**FERGUSON TOWNSHIP PLANNING COMMISSION**  
**Regular Meeting Agenda**  
**Monday, February 13, 2023, 6:00 PM**

**1. MP Machinery and Testing at 2161 Sandy Drive, State College  
Final Land Development Plan**

**RE: MP Machinery and Testing Final Land Development Plan—1<sup>st</sup> Review**

**RE: MP Machinery and Testing ES#436 Final Land Development Plan – Centre Regional Planning Agency Review**

RECORD PLAN

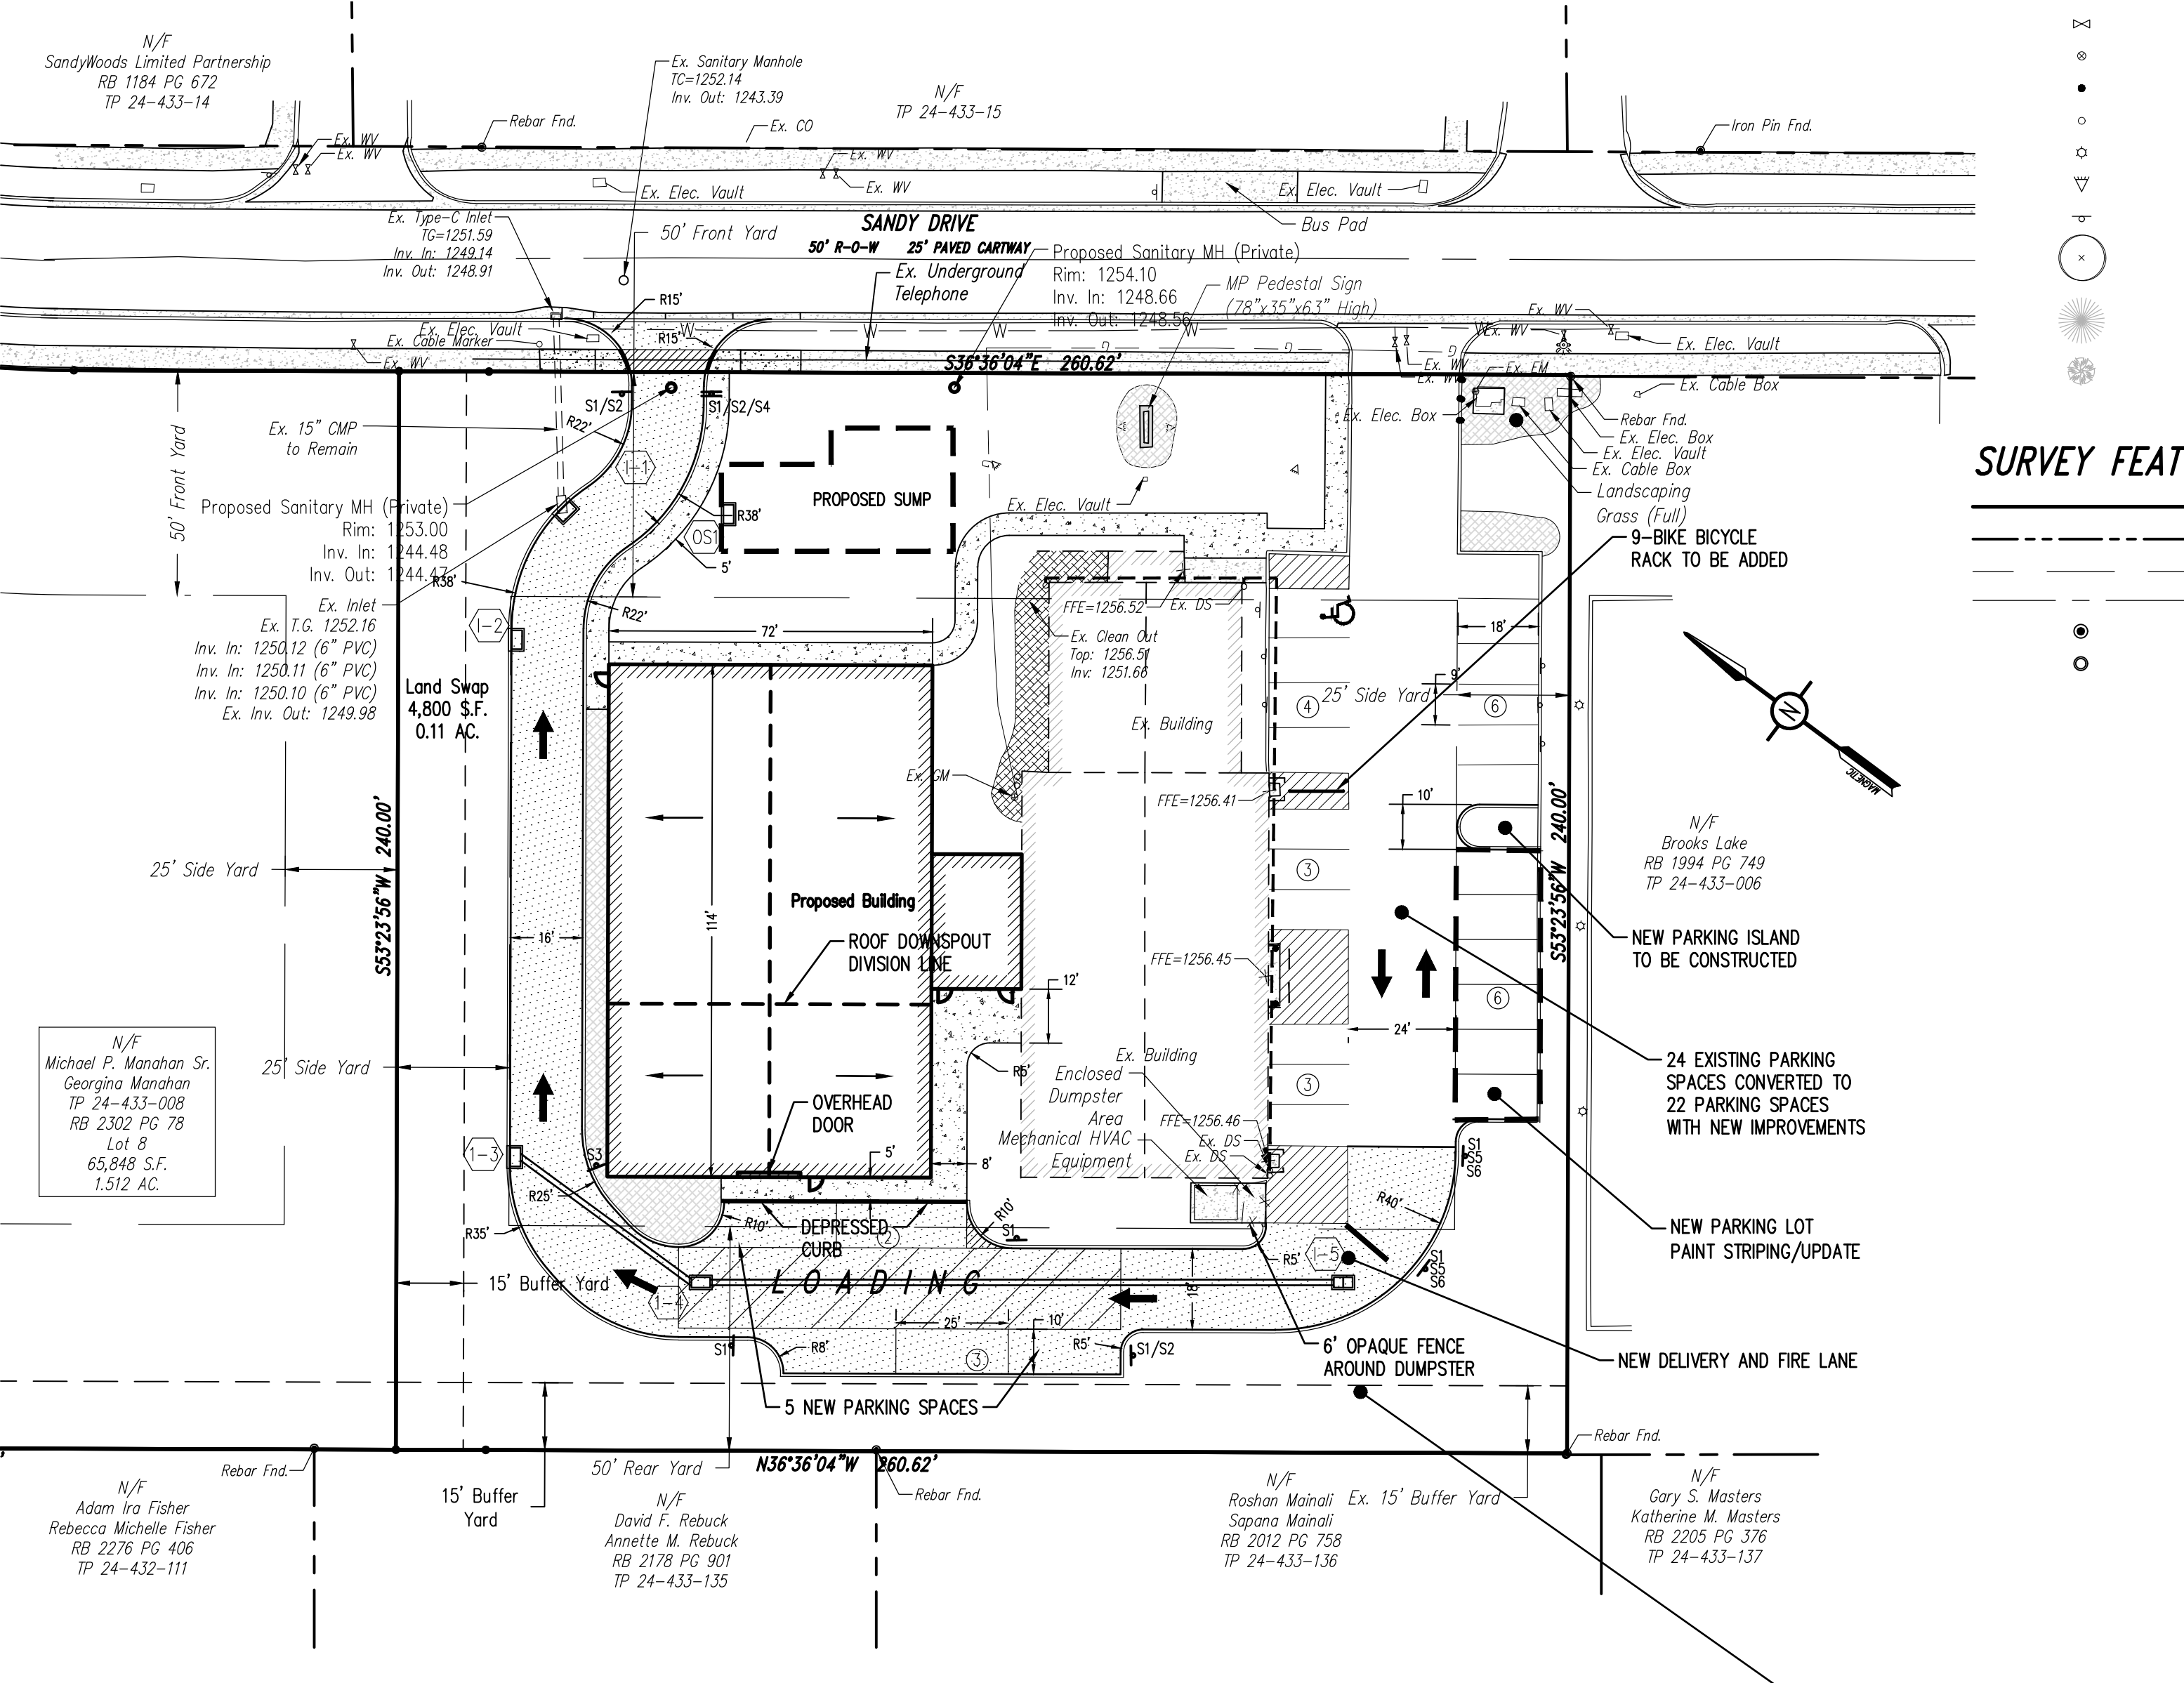
1. On Sheet #3, along the proposed exit drive, there is a note for "Land Swap." This is likely from a previously recorded subdivision plan and should be removed from this plan.
